**Structural Inspection and
O&M, Occupational and Public Safety Review
of the
Hot Springs Tunnel System,
Hot Springs National Park
Hot Springs, Arkansas**

August, 1993

Bureau of Reclamation
Denver Office

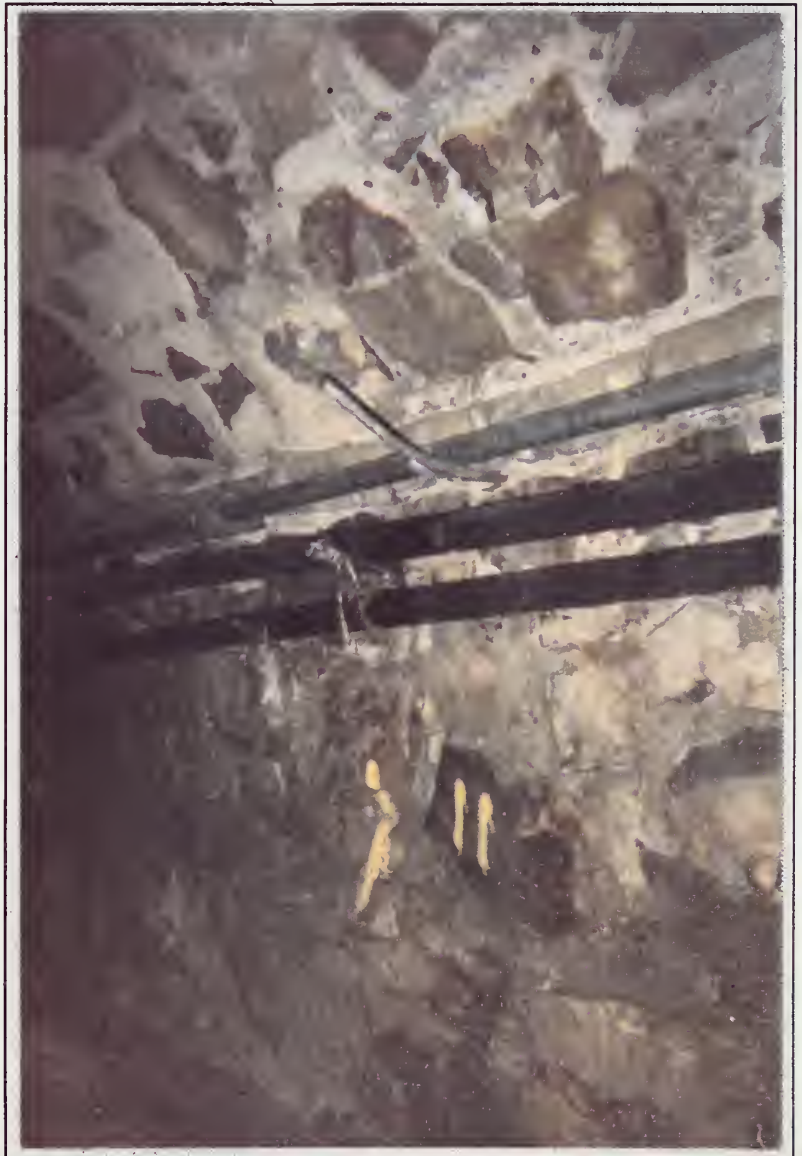
The morning of August 3, those inspecting the tunnel entered the Arch Creek Tunnel at the outlet (about Station 183+00 on Figure 2.3). Photo 3.1 shows the headwall of the outlet.

In the outlet reach the Arch sidewalls are founded on a shale rock unit. Significant undermining of the sidewalls was noted in this reach. Photos 3.2 and 3.3 show erosion at the base of the sidewalls and in the invert of the tunnel.

3.1 Inspection party entering the outlet of Arch Creek Tunnel.
 (About Station 183+00 COE Drainage Map Figure 2.3)

3.2 Sidewall of the Tunnel. The base of the sidewall has been severely undercut. The concrete traces the base of a previous repair. (About Sta. 187+00.)

3.3 Pedestal and Erosion of the Tunnel Invert (About Sta. 190+00)

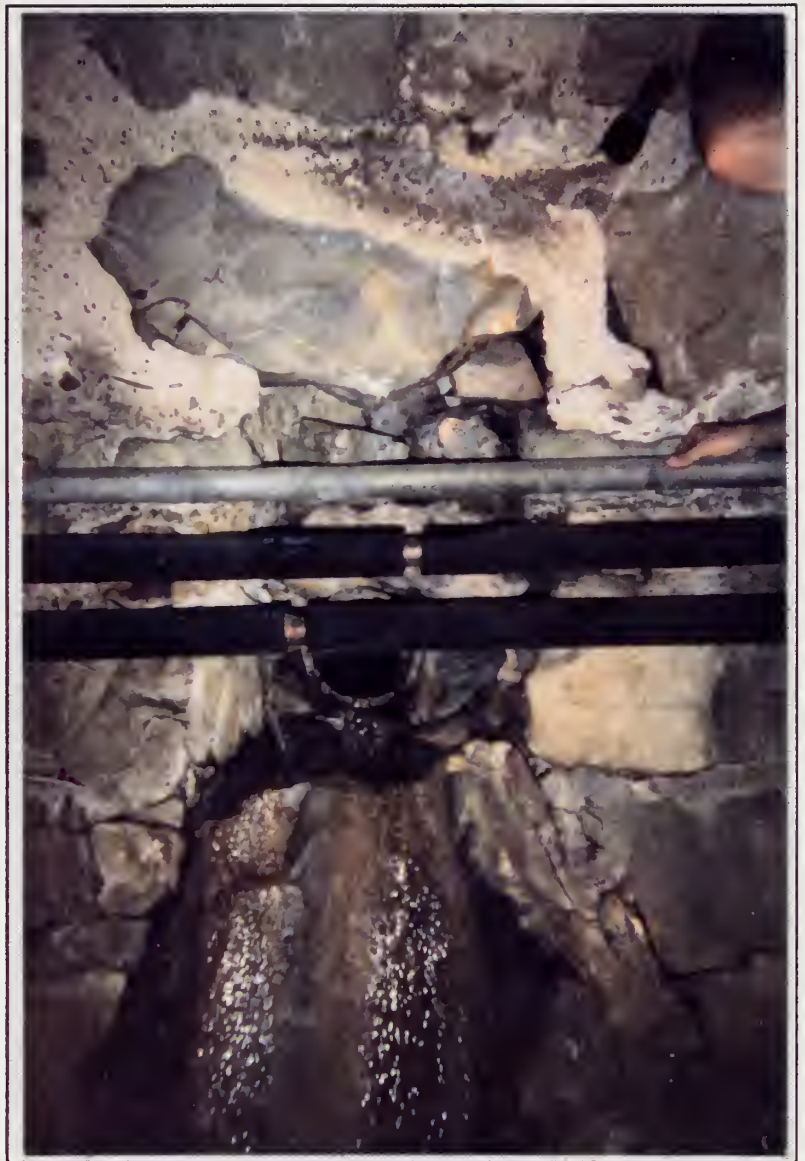
In general the arch appeared to be in good condition loose rock blocks were observed in the sidewalls where the foundation had been undermined, however; the arch and sidewalls usually appeared to be well cemented without loose blocks. Photo 3.4 shows the arch and sidewall of the tunnel. The painted number on the sidewall may be related to a recent Corps of Engineers survey in the tunnel.

Throughout the tunnel openings in the arch and sidewalls are evident. Photo 3.5 shows a pipe entering the tunnel with water flowing down the sidewall of the tunnel. Photo 3.6 shows a wooden blockout in the crown of the tunnel.

After lunch we entered the Whittington Avenue section of the tunnel. Photo 3.7 shows the tunnel entrance on the Whittington leg. A corrugated metal section extends a short distance into the tunnel.

In some reaches the arch has been covered with shotcrete. Photo 3.8 shows a section of the tunnel with a sound shotcrete coating.

In the reaches of the tunnel near Hot Springs Mountain hot water collection and distribution pipes are supported on the sidewalls and occasionally cross the tunnel. Photo 3.9 shows a pipe across the arch.

The shotcrete coating on the arch has eroded in many places through the tunnel. Photo 3.10 shows the deterioration of the shotcrete coating.

Photos 3.11 and 3.12 were taken from the surface after we exited the tunnel. The area is one of immediate concern. After we observed a somewhat haphazard arrangement of structural steel beams and pipe bracing in the tunnel, we inspected the surface to find the remains of an old structure with unprotected openings to the tunnel. The concrete structure was a thin slab supported by the steel beams we observed in the tunnel. It appeared that vehicles could park on the slab. We discussed the apparent danger with the city representative Dave Stanage on the spot. Structural modifications to this area are needed.

Photo 3.13 again shows erosion at the base of the sidewall of the tunnel. This photo was taken in a section upstream of the Fordyce Bathhouse Visitor's Center. Again the masonry of the sidewalls appears to be in good condition.

3.4 Arch and Sidewall. (About Sta. 200+00)

3.5 Drainage Entering the Tunnel.
(About Sta. 205+00)

3.6 Crown of the Tunnel. Wooden blockout for drainage into the tunnel is visible in the crown. (About Sta. 200+00)

3.7 Whittington Avenue Entrance. The structural steel plate is just visible inside the tunnel. (About Sta. 72+00 Whittington Ave Branch COE Map Figure 2.3)

3.8 Tunnel Crown. Shotcrete or gunite treatment. (About Sta. 60+00 Whittington Branch)

3.9 Insulated Piping Crossing the Tunnel Crown.

3.10 Deterioration of the Shotcrete in the Crown of the Tunnel. (About Sta. 235+00)

3.11 Vault near Arbor and Loadstone Streets. (About Sta. 238+00)

3.12 Vault near Arbor and Loadstone. Unprotected opening and slab thickness are shown.

3.13 Erosion of the Base of the Sidewalls of the Tunnel.
Erosion of previously placed concrete is visible.
(About Sta. 240+00)

1993-T1-1. Fence the vault area near the intersection of Loadstone and Arbor streets and cover openings to the tunnel.
